LUXURY HADDAD APARTMENTS 2324 JOHNSON STREET TAC #18-DP-33

TECHNICAL ADVISORY COMMITTEE REPORT

18-DP-33

Site Plan Review for a 12 unit residential development (Haddad Luxury Apartments).

SHEET NUMBER L-200

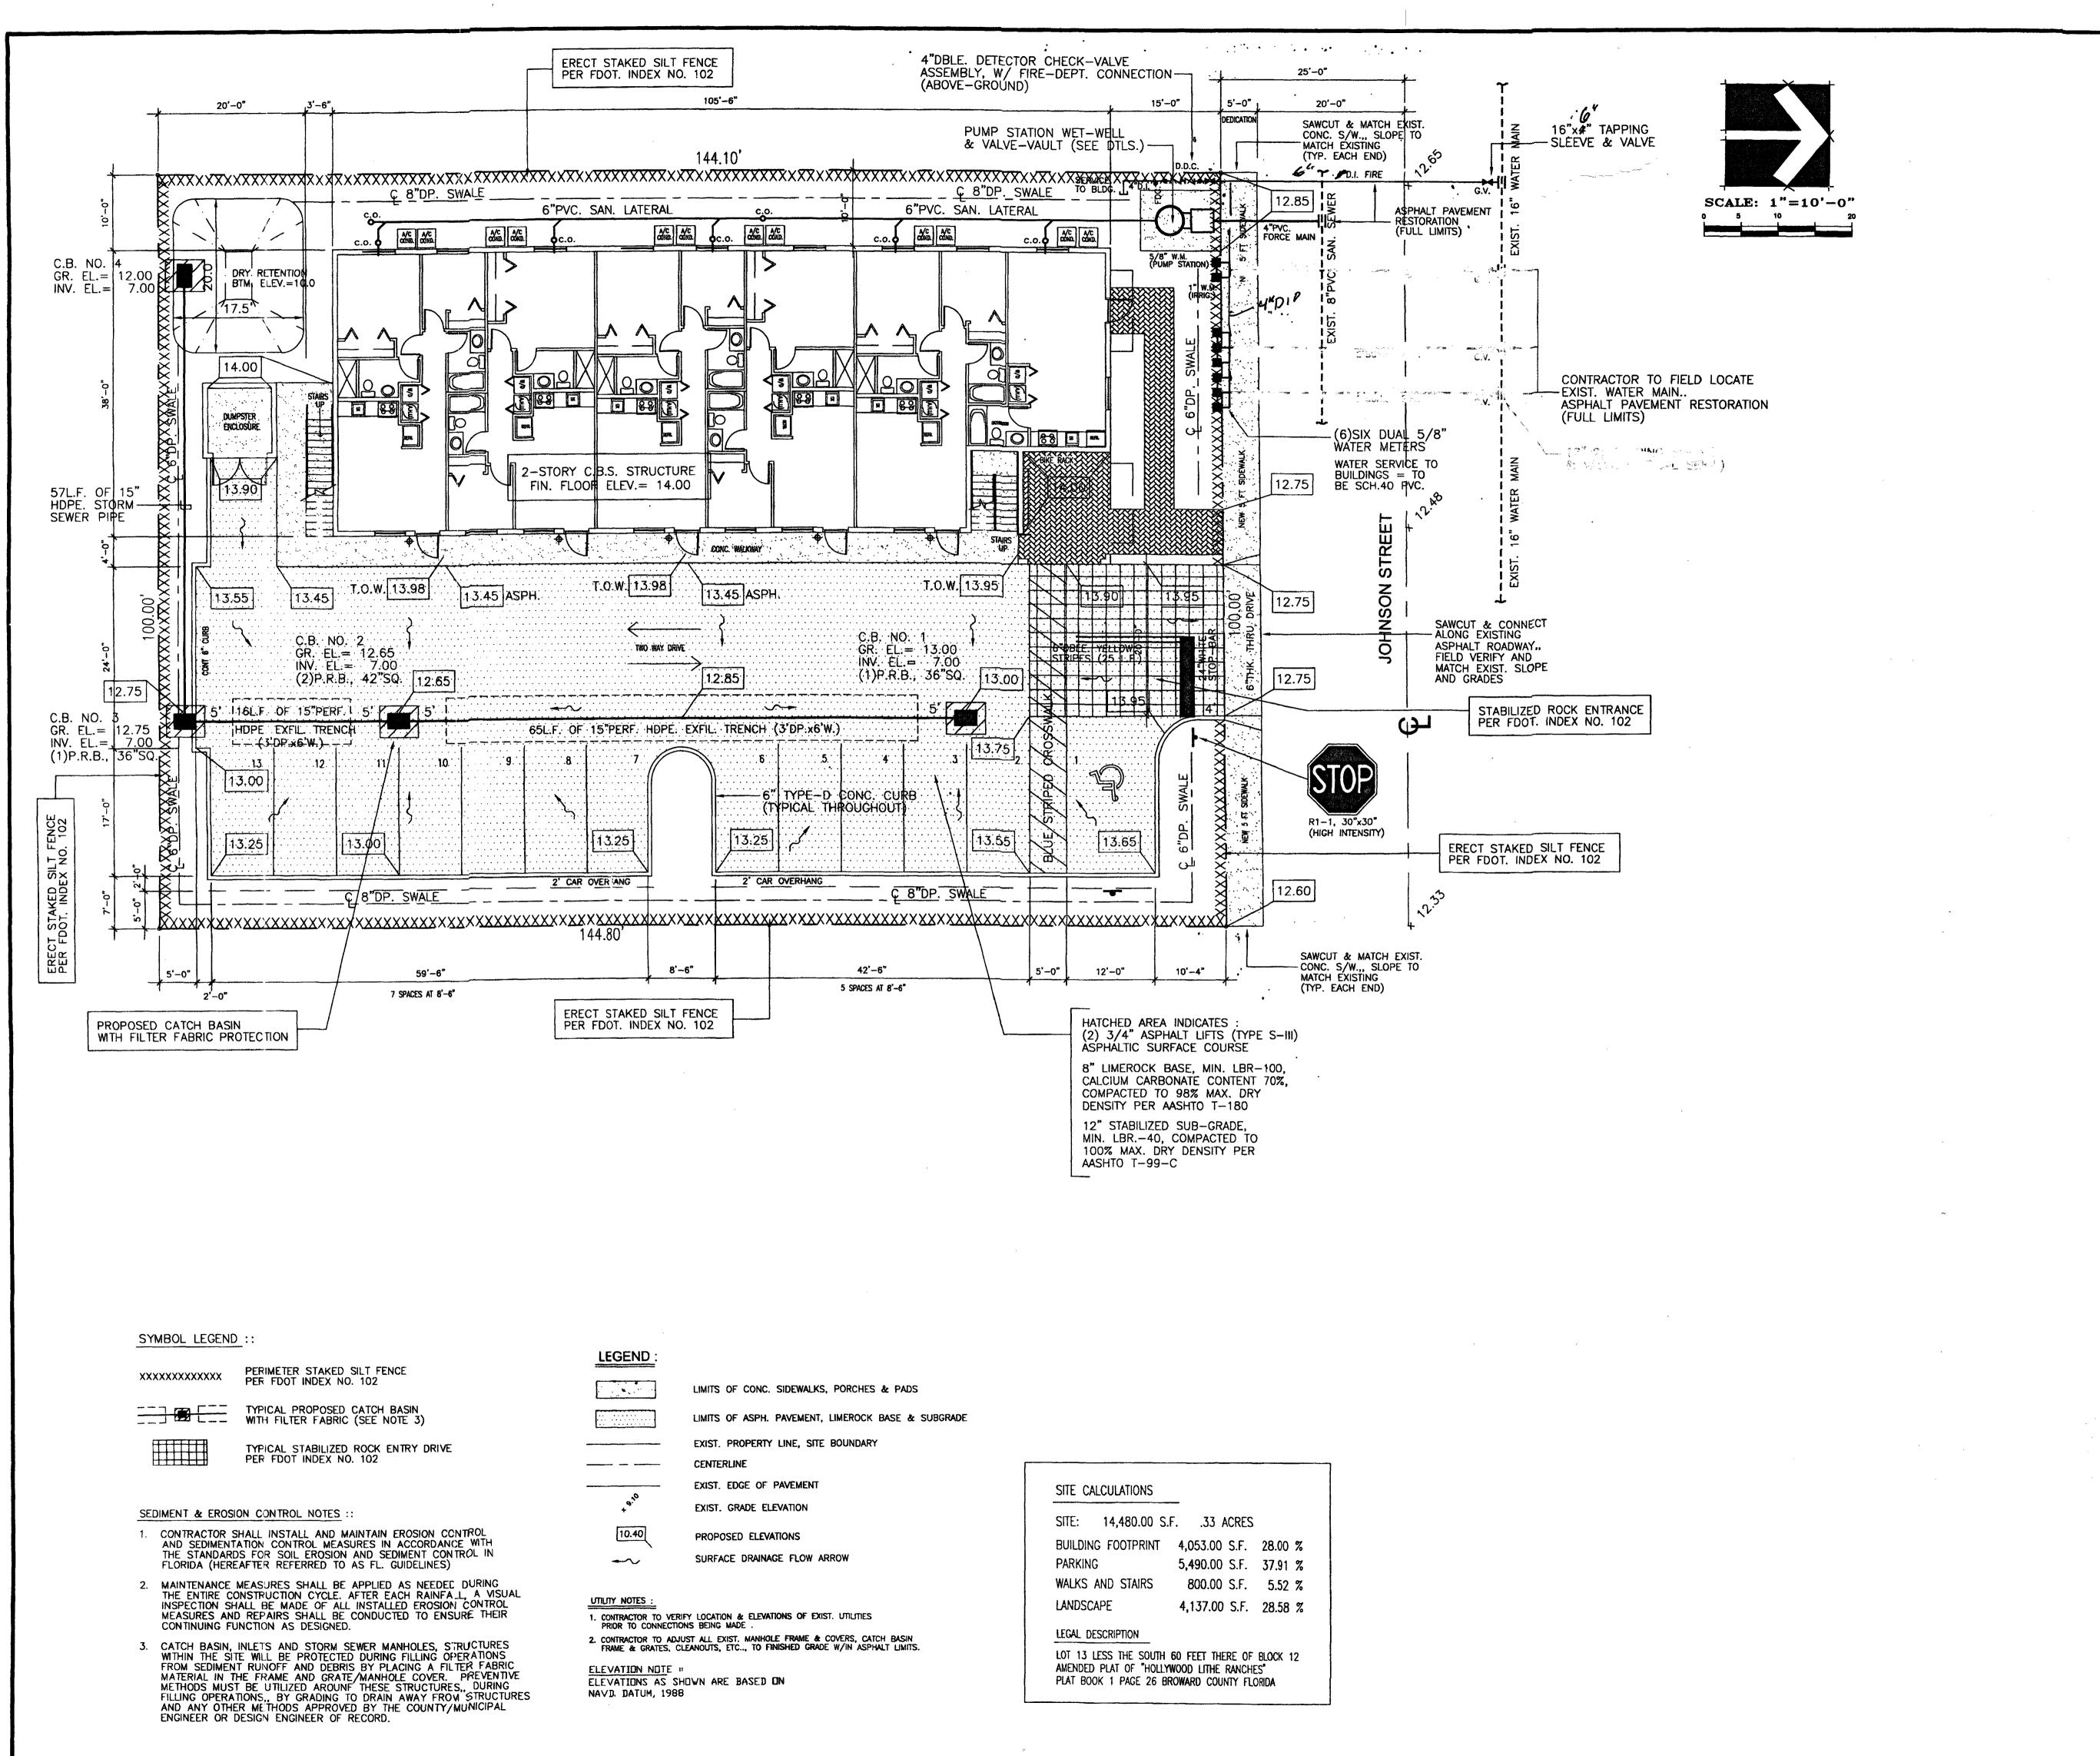
- As per submitted landscape planting plan L-200 please provide further clarification in regard to tree
 mitigation total inches of DBH in lieu of hardwoods and thirty one (31) palm trees removed
- Clarity is still needed to define code required ten (10) trees and separate owed 31 palms and 66" DBH broadleaf tree mitigation please provide a plant list table that clearly defines both with a symbol or within description area of proposed landscape table.
